## MEMORANDUM

**DATE:** October 5, 2015

**SUBJECT:** ZC #15-10 - Final Report - Consolidated Planned Unit Development and Related Map Amendment from the C-M-1 District to the R-5-B District (Square 5197, Lot 809) (Deanwood Hills)

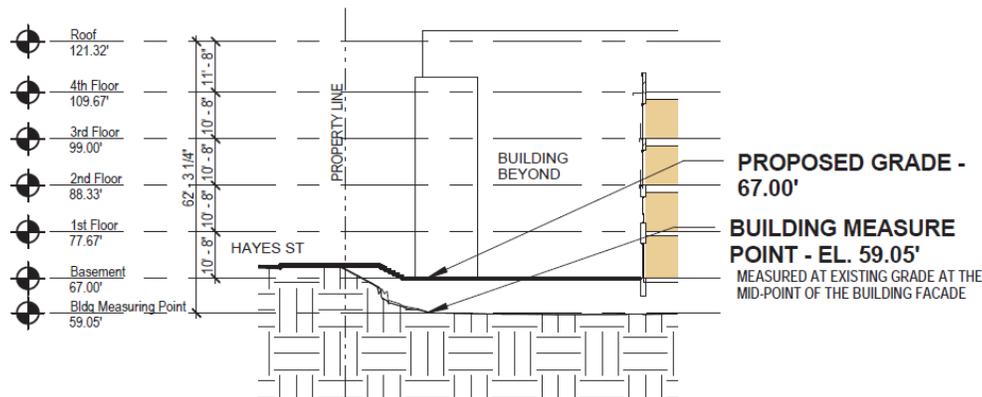
The building's height at 62.25 feet would be due in part to the existing grade difference between the street and the site, as measured from grade at the building's façade. The proposed grade and measuring point reproduced here from the applicant's submission (Exhibit 4A1- Sheet 09) best explains the existing condition and how the height would be measured.

The 2-foot deviation from the 60-foot maximum permitted height is intended to accommodate the grade changes, and to provide typical nine foot floor-to-ceiling heights for the units. OP does not object to the requested height relief.
